RETREAT AT TIMBERRIDGE FILING NO. 1

CONSTRUCTION DRAWINGS

AUGUST 2019

DESIGNED BY	PRA	SCALE	DATE	04-05-19
DRAWN BY	ESO	(H) 1" = 60'	SHEET	5 OF 35
CHECKED BY	(V) 1" = N/A	JOB NO.	1185.00

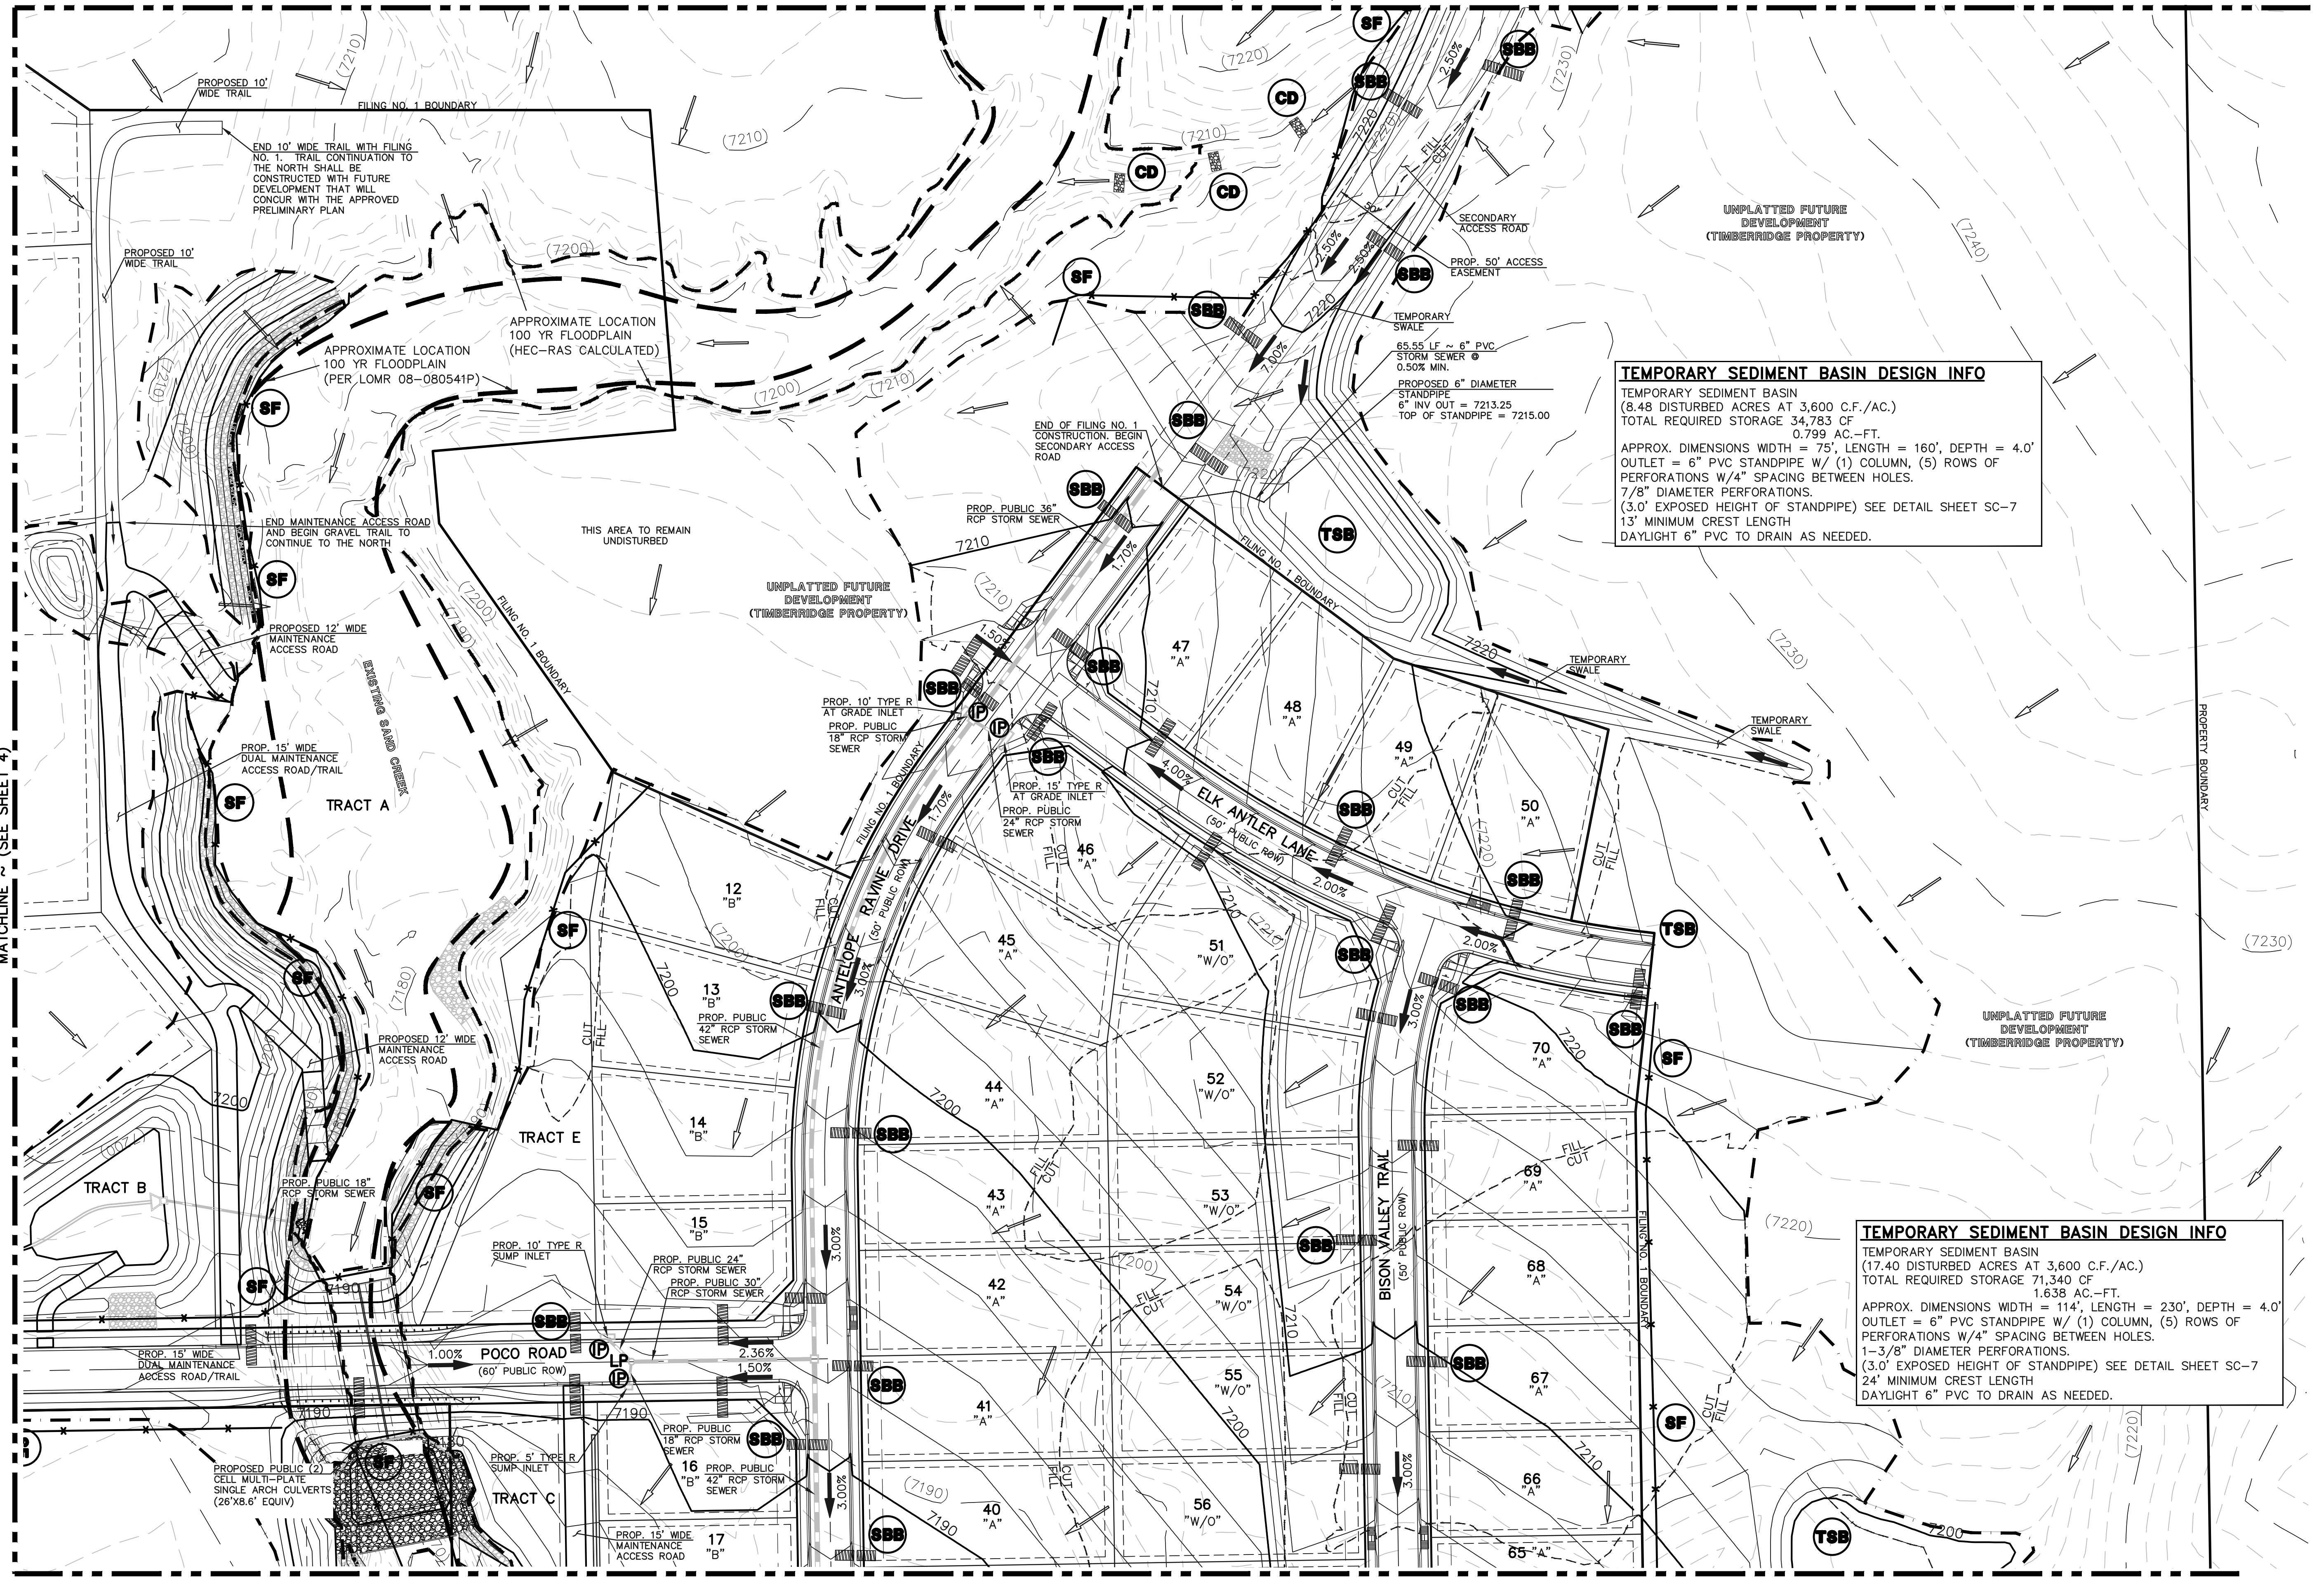
add "entire" (typ.)
 Unresolved.
